SUBJECT: Coastside Design Review Recommendation
Cortez Avenue, Miramar
APN 048-032-070; County File No. PLN 2018-00397

At its meeting of April 11, 2019, the San Mateo County Coastside Design Review Committee (CDRC) considered your application for design review recommendation to allow construction of a new 1,732 sq. ft., two-story single-family residence, plus a 380 sq. ft. two-car attached garage, located on an existing 4,400 sq. ft. legal non-conforming parcel (legality confirmed via PLN2014-00116), as part of a hearing-level Coastal Development Permit (CDP) and a Non-Conforming Use Permit (UP). The Use Permit is required to allow development on a non-conforming parcel that proposes right and left side setbacks of 5 feet. and 7 feet., respectively, where 10 feet. is the minimum allowed for each side. No trees are proposed for removal. The Coastside Design Review Committee was unable to determine the findings for design review approval based on certain design deficiencies. In order to resolve these deficiencies in the project's design, a more thorough review of the "Standards for Design for One-Family and Two-Family Residential Development in the Midcoast" manual is required, with

ROOF and Roof Deck Plan

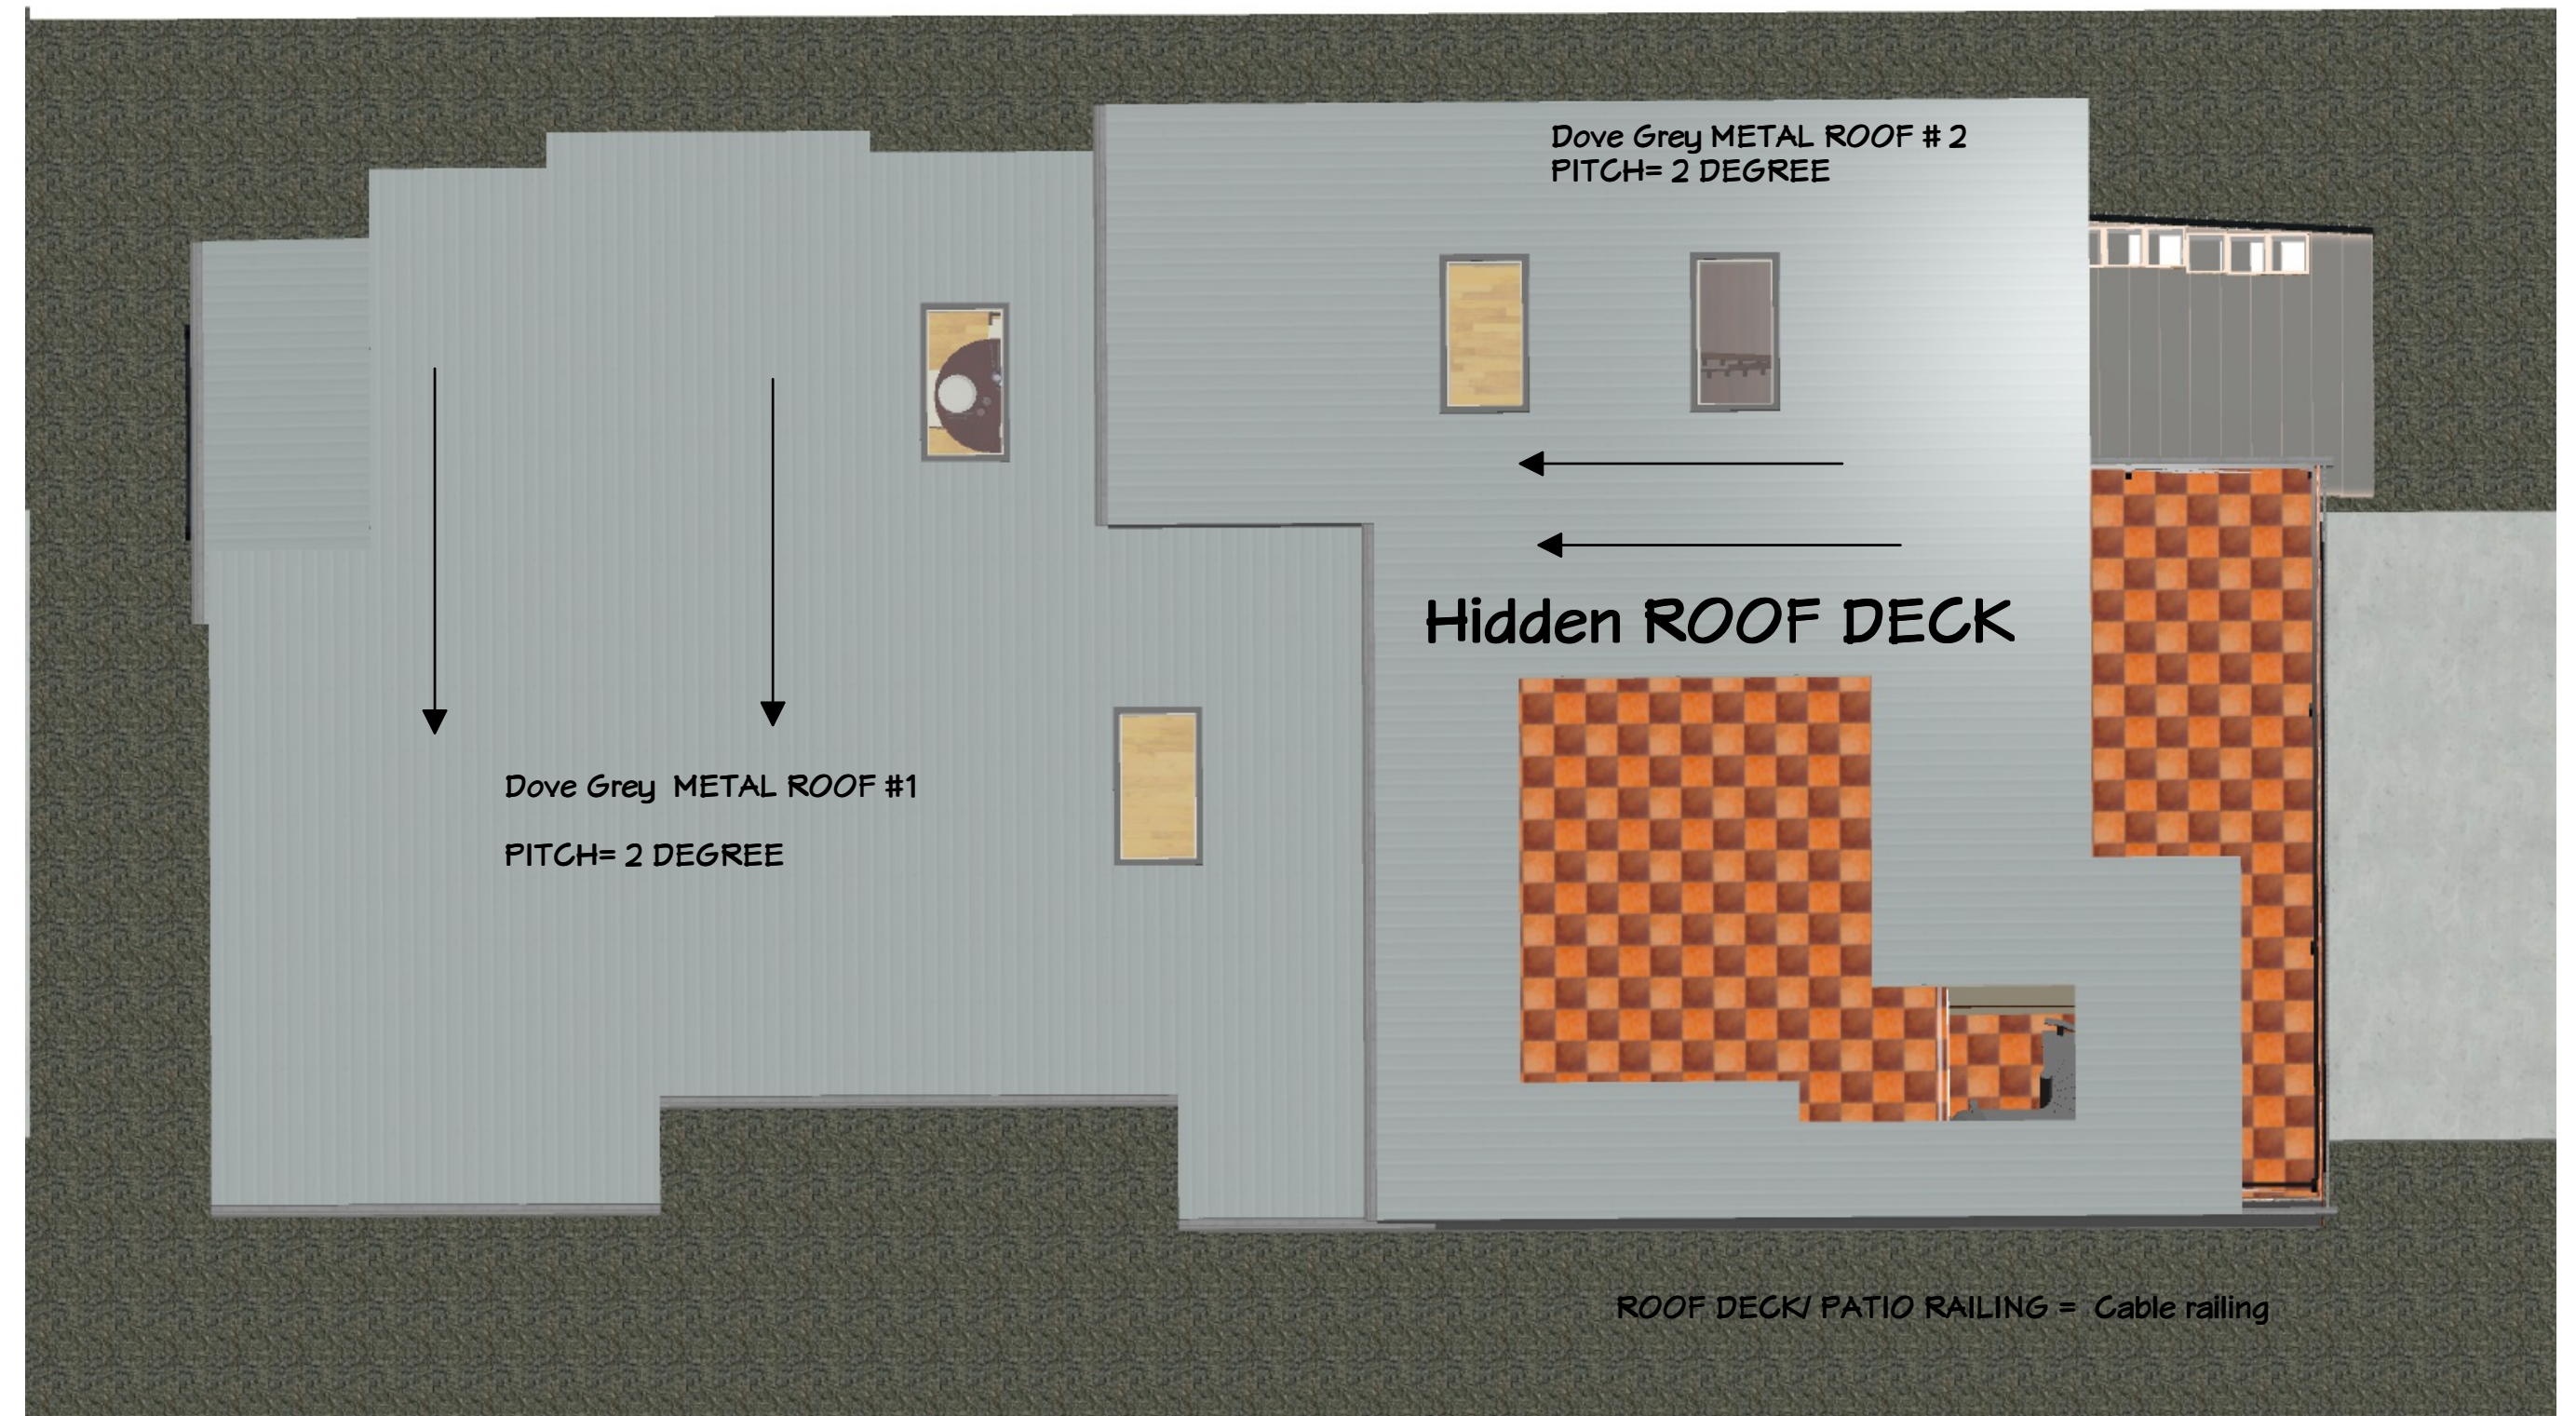
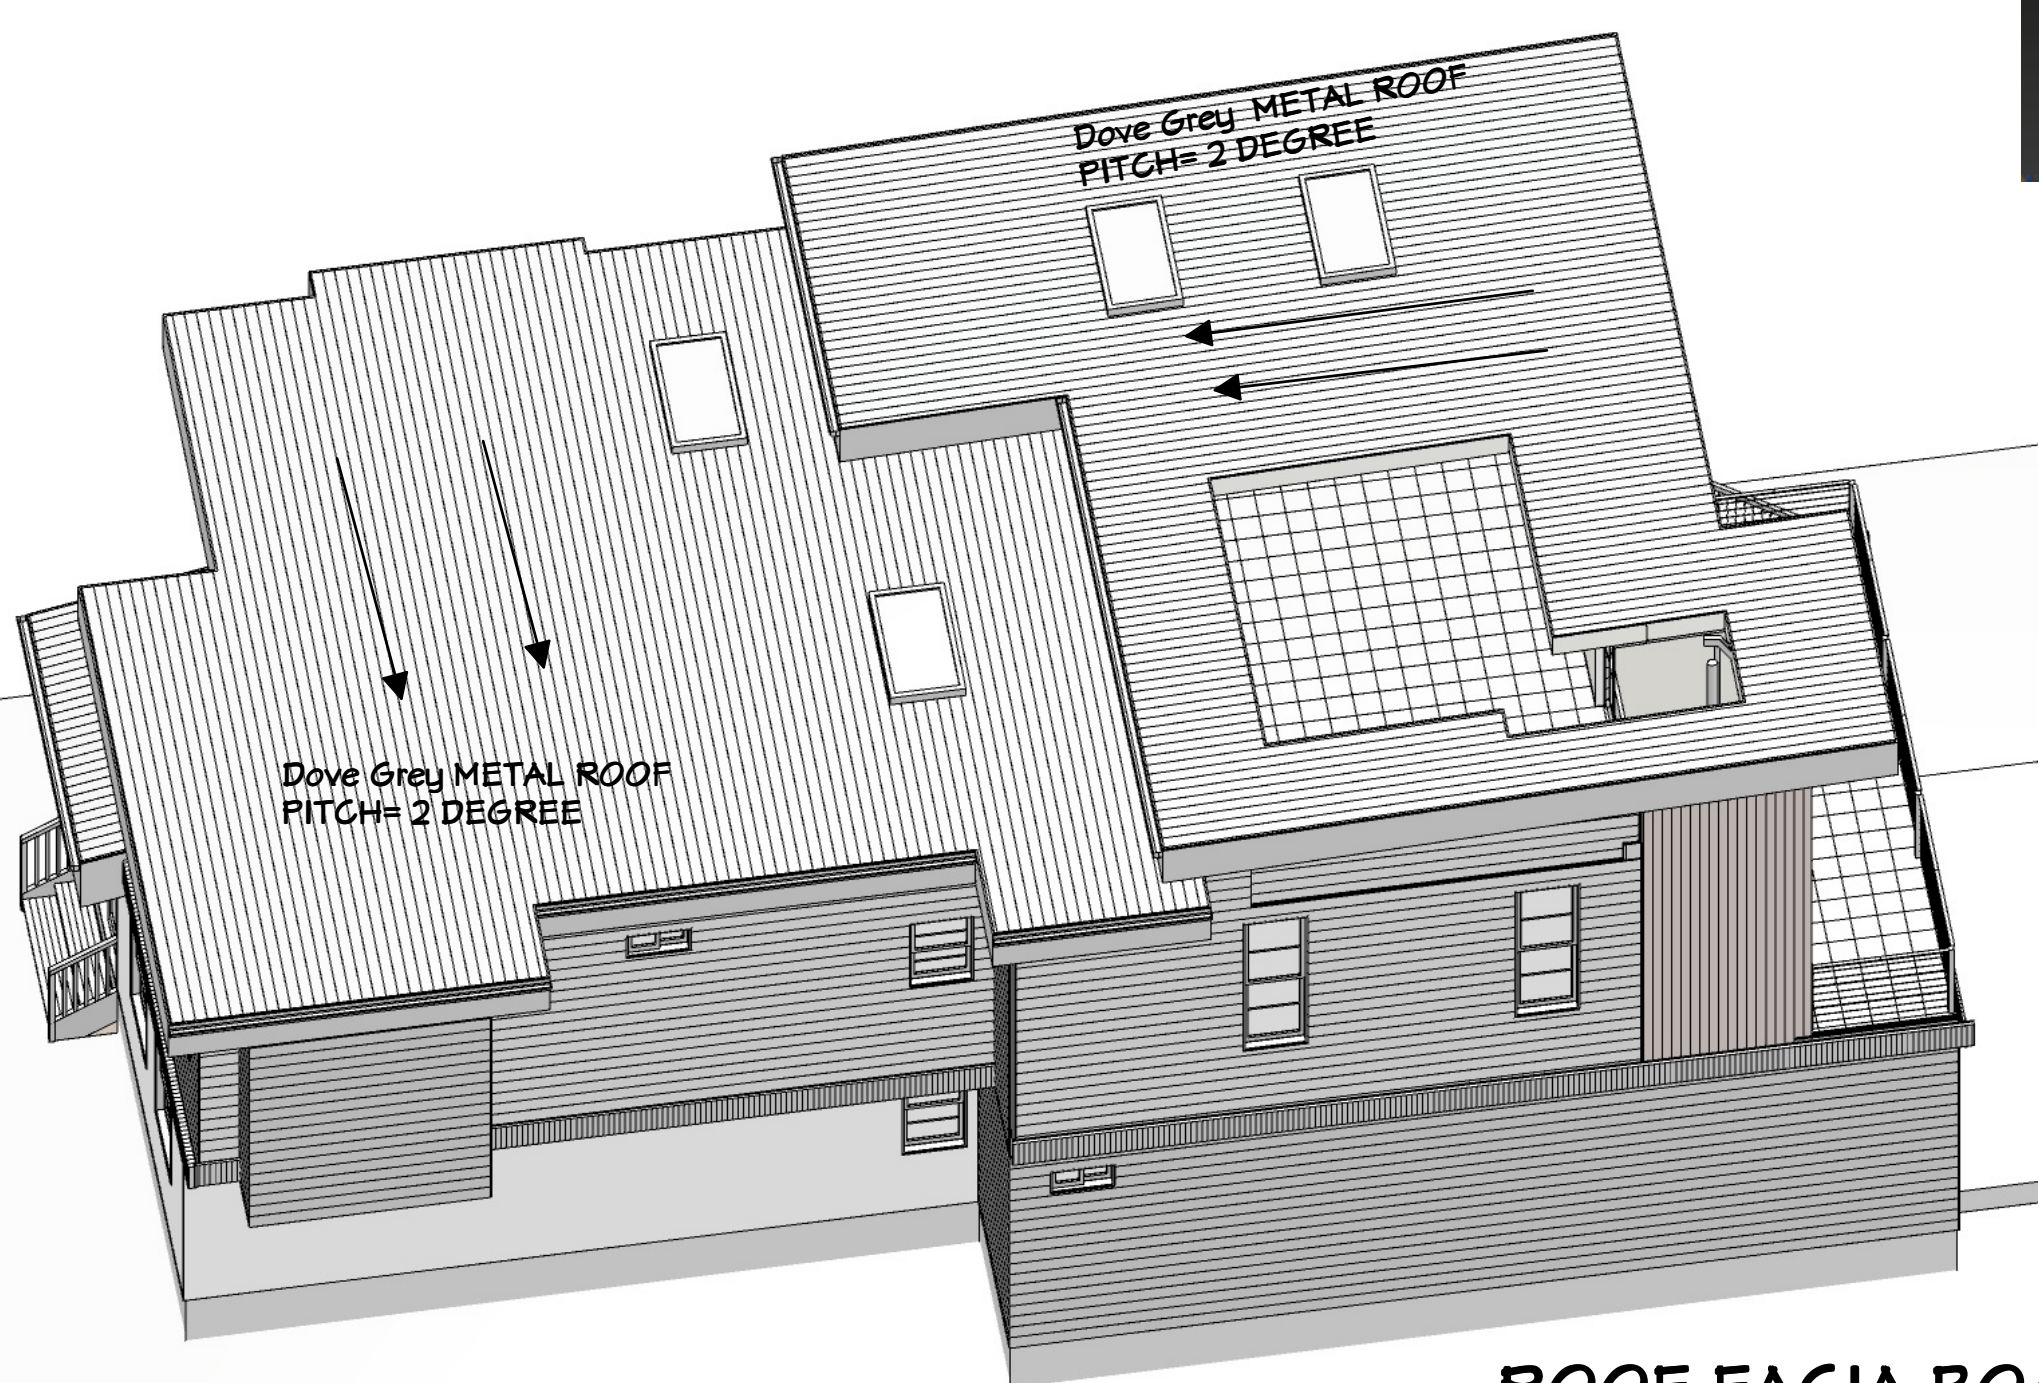
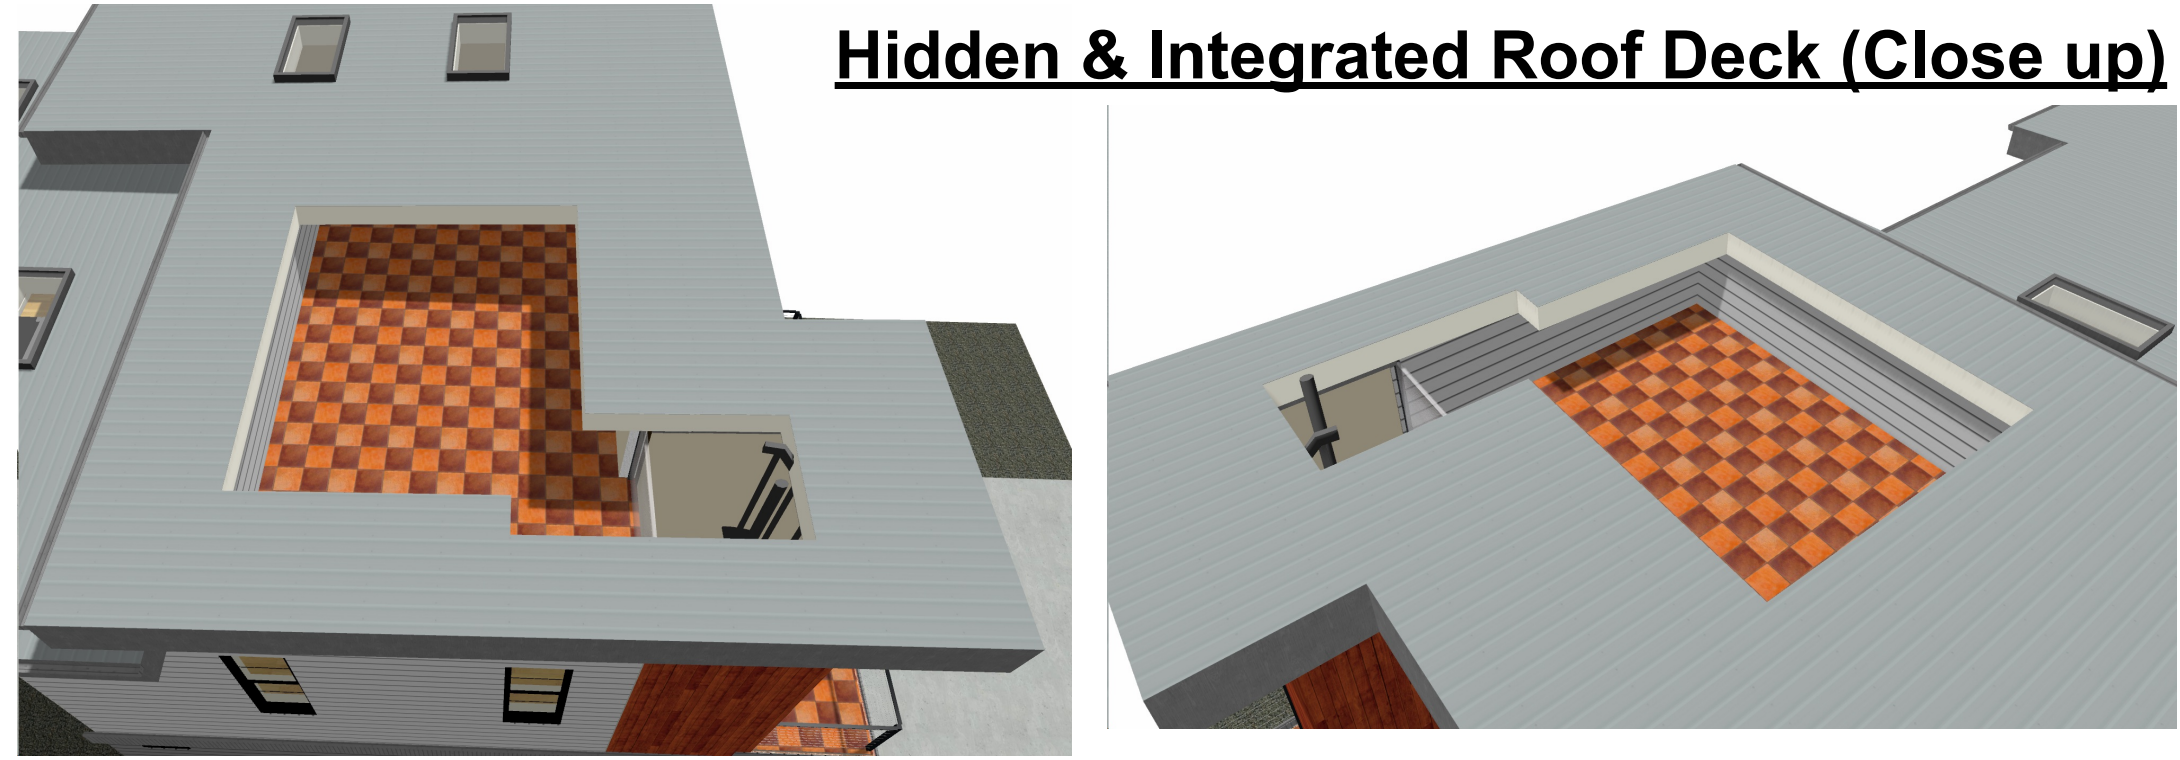
6. Use exterior colors closer in tonality, soften colors, no black trim, and roof.
7. Consider using cable rail and parapet wall sections on roof deck.
8. Reduce vertical wall sections, use of both glass and stucco should be lessened to modulate the roof form so that it does not have a single slab appearance.

9. Reduce height of roof fascia. Ensure fascia height is consistent for all rooflines.
10. Lower roof height to reduce vertical height at front door.
11. Spiral stair access to upper roof deck needs to be internal, and size shown accurately.

13. Upper level deck should be aesthetically subordinate to overall architectural style.
14. Group plantings for a more natural effect.
15. Incorporate a tree/plant species, plants that grow to a more substantial height and have longevity in a coastal zone, in the landscape plan. Roses are not recommended.

- Consider using cable rail and parapet wall sections on roof deck.
Redesign: Roof deck now complete hidden, ~~Now~~ part of the roof. Patio glass panel is now replaced with cable railing with black galvanized posts.

- Reduce height of roof fascia. Ensure fascia height is consistent for all rooflines.
Redesign: Roof fascia reduced from 2ft to 18inches. Soffit is now boxed.

- Lower roof height to reduce vertical height at front door.
Redesign: Roof now complete redesign. Vertical height at the front door has been replaced with one single roof that covers the front door and roof deck. This reduce the force verticalness at the front door.

- Spiral stair access to upper roof deck needs to be internal, and size shown accurately.
Redesign: Spiral stair case now completely hidden. Spiral stair case is accessible now from inside and spiral stair case is now part of the roof design. Size now correctly shown.

- Upper lever deck should be aesthetically subordinate to overall architectural style.
Redesign: Roof deck now competed hidden, part of roof, cannot be seen from any side. Only from top. Patio is now smaller because of hidden spiral stair case. This solve decks privacy concern, aesthetics and make roof/ Patio and roof deck proportional.

- Consider pulling guardrails for roof decks away from the edge of roof to reduce the visual impact and improve privacy for neighboring property.
Redesign: Roof deck now complete hidden, Cannot be seen from anywhere. For privacy concerns roof has been added to the sides so even if someone is standing on the roof deck they cannot directly see below.

- Roof redesigned
- Roof deck completely hidden from public eye
- Roof deck now integrated into roof.
- Roof deck Privacy concerns met with roof on the edges

ROOF FACIA BOARD WIDTH = 18 inches (Box Soffit)

Roof Deck completely hidden , integrated into the roof design

ROOF DECK AREA = 194 SQFT (Reduced from 300 SQFT)
